Technical Bulletin

Bulletin No: TCH-008-033-A

Subject: **TRAILER SYSTEM-GUARD™ PRODUCT IMPROVEMENT**

**Obsolete
Trailer System-Guard
Pc. Nos.**
5006050 & 800676

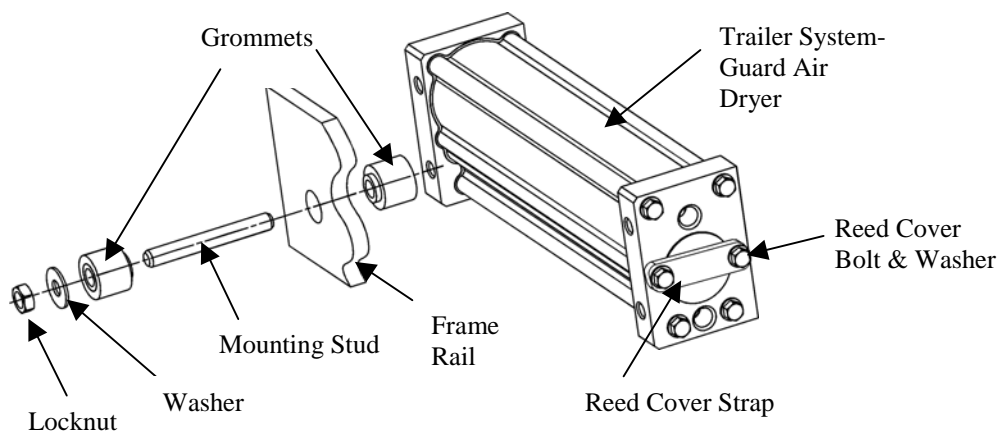
The defect is that the retaining bolts for the reed valve covers on either end of the Trailer System-Guard air dryer may crack, causing the bolt heads to come off. If this occurs, the trailer can lose service braking and/or the trailer parking brakes can engage without warning. There have been no reports of any accidents or injuries.

The Trailer System-Guard Air Dryer piece numbers below are to be removed and replaced with service piece number 800765. These piece numbers will include a reinforcing strap over the reed valve cover and additional mounting hardware (shown) that will isolate the Trailer System-Guard from the mounting surface to prevent stress from being placed on the unit.

**New Service
Replacement
Pc. No.**
800765

**New O.E.
Pc. No.**
5007786

Do not attempt to modify the existing air dryer or install the mounting hardware kit on the old Trailer System-Guard.
